NORTHERN BEACHES LOCAL PLANNING PANEL

WEDNESDAY 4 MAY 2022

ITEM 4.1	DA2021/1991 - 12 BIRKLEY ROAD, MANLY - DEMOLITION WORKS AND CONSTRUCTION OF A DUAL OCCUPANCY (ATTACHED) INCLUDING STRATA SUBDIVISION
AUTHORISING MANAGER	Rodney Piggott
TRIM FILE REF	2022/248666
ATTACHMENTS	1 Assessment Report 2 Site Plans and Elevations

Note: Height poles were erected on the site at the request of Council in the positions indicated on the below surveyor's certification.

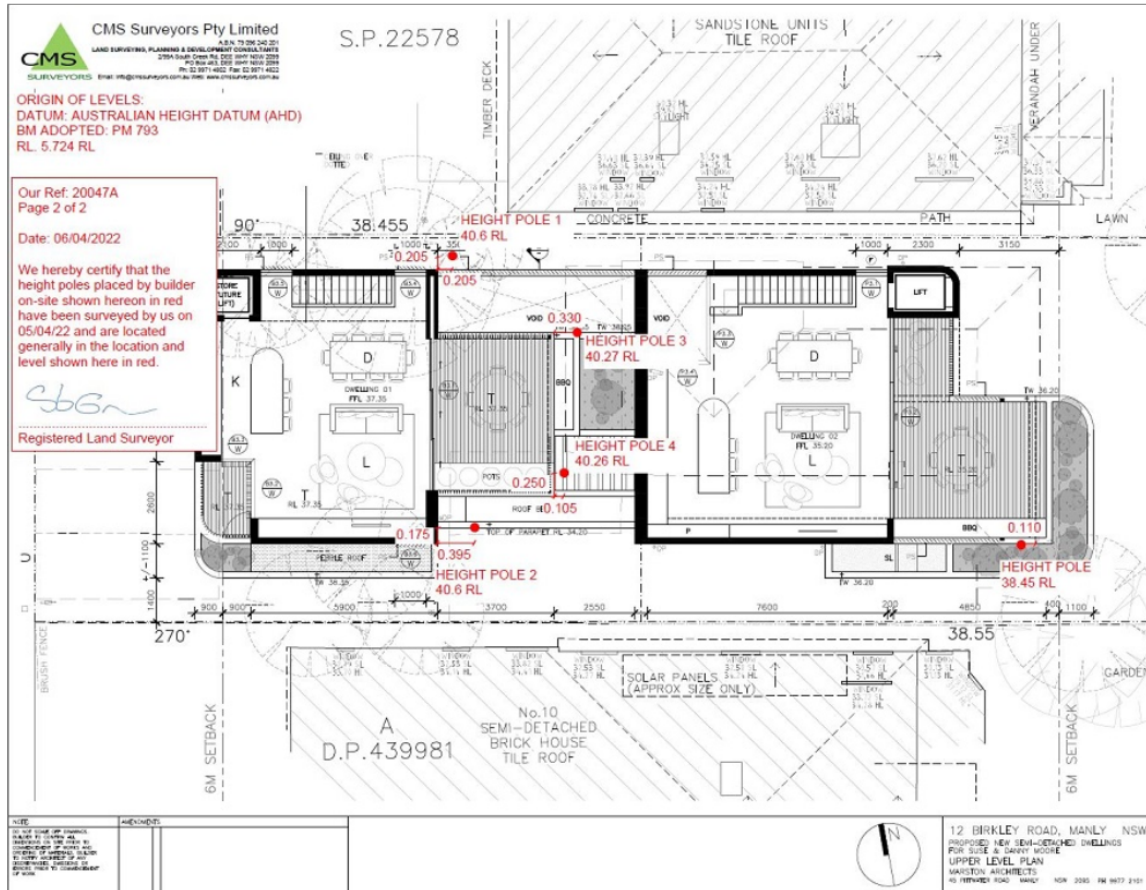
In determining the extent of potential view loss to adjoining and nearby properties, the four (4) planning principles outlined within the Land and Environment Court Case of *Tenacity Consulting Pty Ltd Vs Warringah Council (2004) NSWLEC 140*, are applied to the proposal.

The proposed setback non-compliances are highlighted on the plans below. The shaded areas indicate the non-compliant wall areas, while the solid red outlines indicate the areas of non-compliance that are reduced or removed as a result of the amendments required by condition.

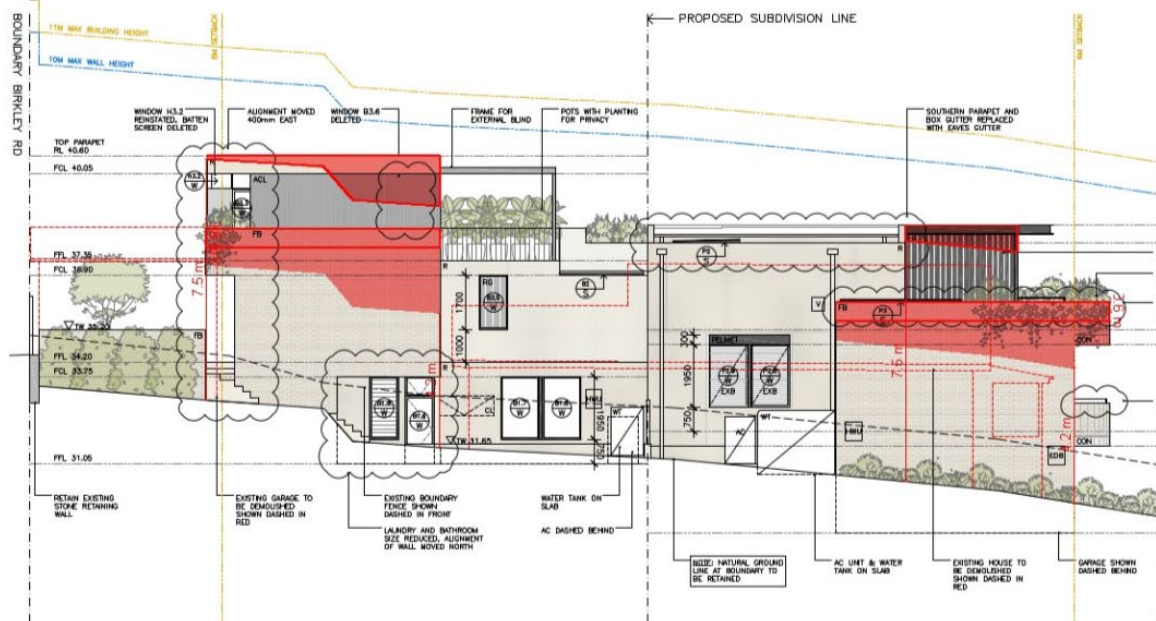
- The proposed 1m setback to the Dwelling 01 level 3 wall is non-compliant with the 2.37m-2.77m requirement
- The proposed 1m setback to the Dwelling 02 level 3 wall is non-compliant with the 2.37m-2.5m requirement
- The proposed 1.2m setback to the Dwelling 02 lift is non-compliant with the 2.53m requirement

- The proposed 1.4m setback to the Dwelling 01 level 2 wall is non-compliant with the 1.77m-2.27m requirement
- The proposed 2.5m setback to the Dwelling 01 level 3 wall is non-compliant with the 2.53m-3m requirement
- The proposed 1.4m setback to the Dwelling 02 level 2 wall is non-compliant with the 1.8m-2.13m requirement
- The proposed 2.5m setback to the Dwelling 02 terrace is non-compliant with the 2.67m-2.77m requirement

The recommended conditions require the following changes to the built form that will reduce/remove the southern side setback non-compliances:

Plan 1. West Elevation of approved Mod2021/0317 (Construction Certificate plan).

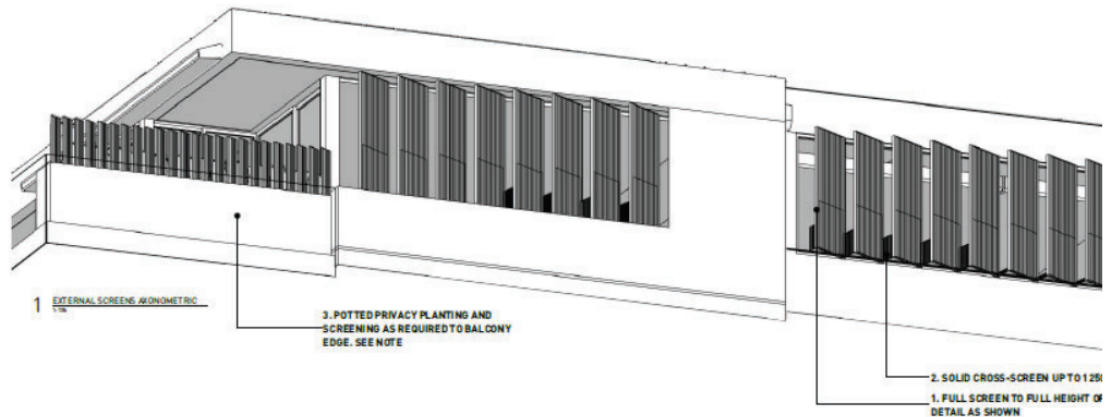
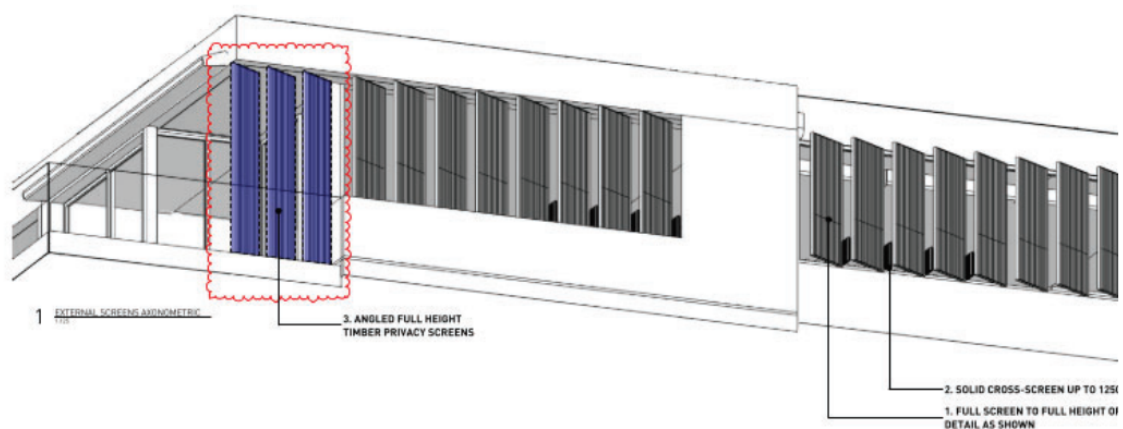
The below plans reflect the form of the privacy screening required by conditions 7, 8 and 9 of the approved Mod2021/0317.

Mod2021/1009, the subject modification, seeks to further revise the balcony privacy screen design, including a reduced screening length and deletion of the adjacent planter box. The proposed modification would require the further amendment of condition 8 and the deletion of condition 9. No change is proposed to the window privacy screening required by condition 7 of Mod2021/0317.

8. The external screens with vertical fins referred to in (7) above shall be replicated in size and continued in a northerly direction for a length of 1.62 metres from the external wall of the dwelling along the western edge of the external balcony accessible from the living area of No. 84 Bower Street, Manly as depicted on plans S4.55-A-101 and S4.55-A-203 prepared by Smith and Tzannes.

Figure 1 - Plan extract showing the existing and proposed building outline relative to the foreshore building line shown in blue existing building outline relative Foreshore building line map extract with subject site shown by red star

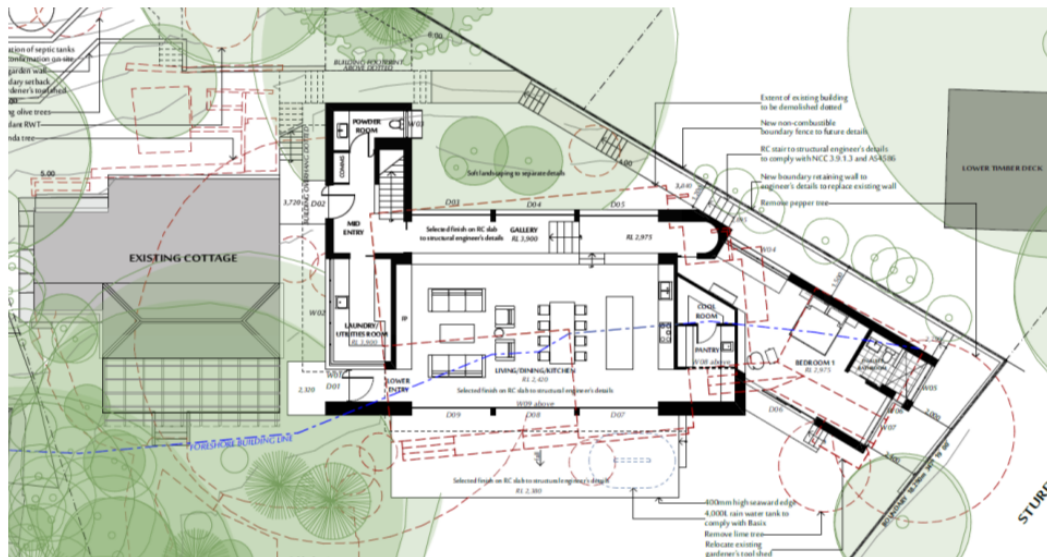
The ground floor terrace and minor sections of the ground floor will encroach further into the foreshore building line than the existing dwelling to be demolished. The extent of the proposed works within the foreshore building line as depicted in Figure 1 over page.

Figure 2 Proposed works

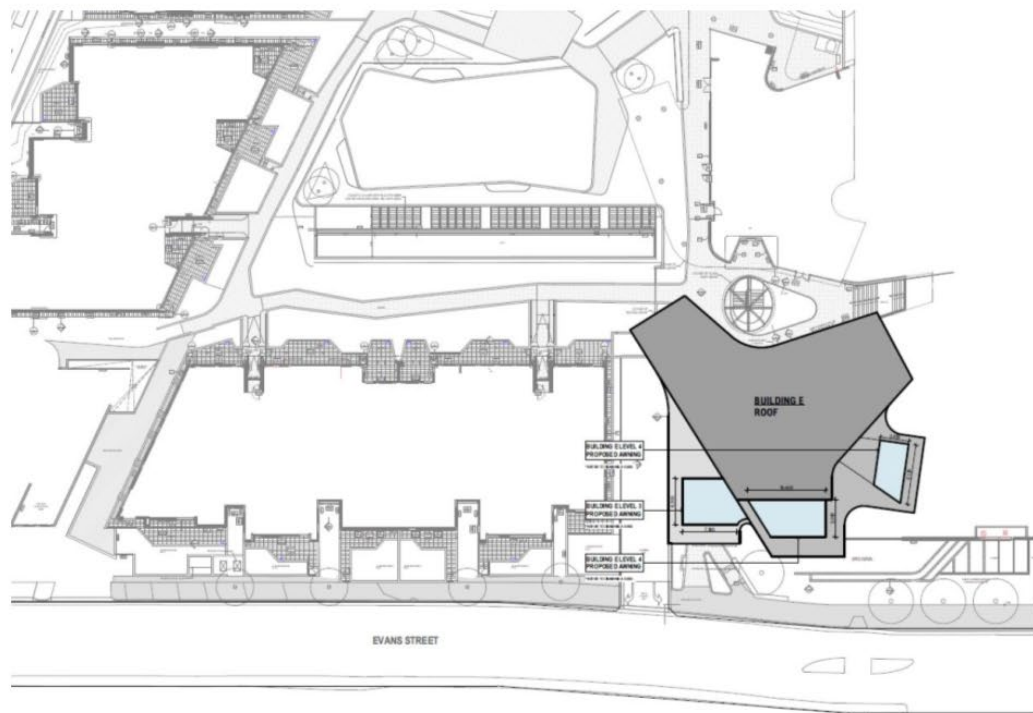
Figure 2 displays the location of the awnings. **Figure 3** displays the proposed works in reference to the 8.5m height plane.

Figure 1 - Extract of approved floor plan of storage area.

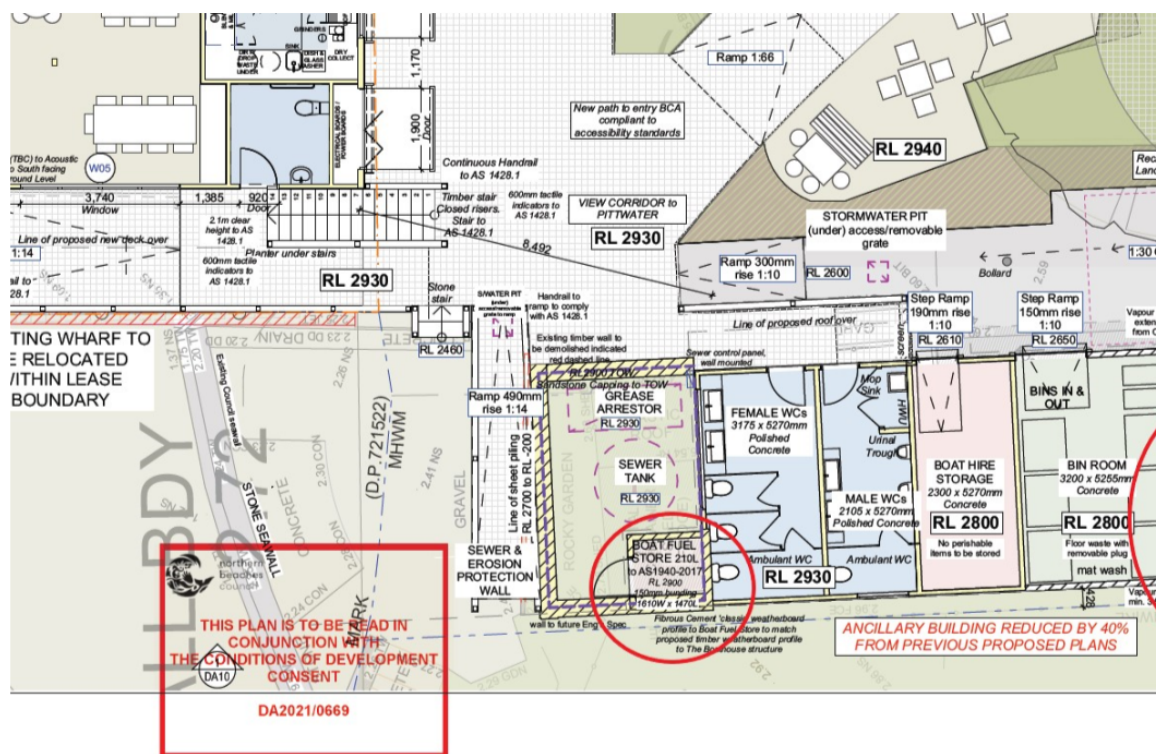
However, Council's Planner is of the opinion that this condition has two aspects, the first being construction requirements for the storage of the dangerous goods (LPG and Boat Fuel store) in accordance with the dangerous goods assessment and the second component being the management of dangerous goods.

The Dangerous Goods Assessment makes recommendations as to the structural requirements of the dangerous goods storage area, these areas identified on the following approved plan:

Therefore, it is recommended that the condition is amended to remove the requirement to update the plan of management to deal with the storage of dangerous goods 'prior to an occupation certificate' and maintain the requirement for the recommendations of the dangerous goods assessment to be implemented into the construction certificate with regards to the structural recommendations of the storage areas.
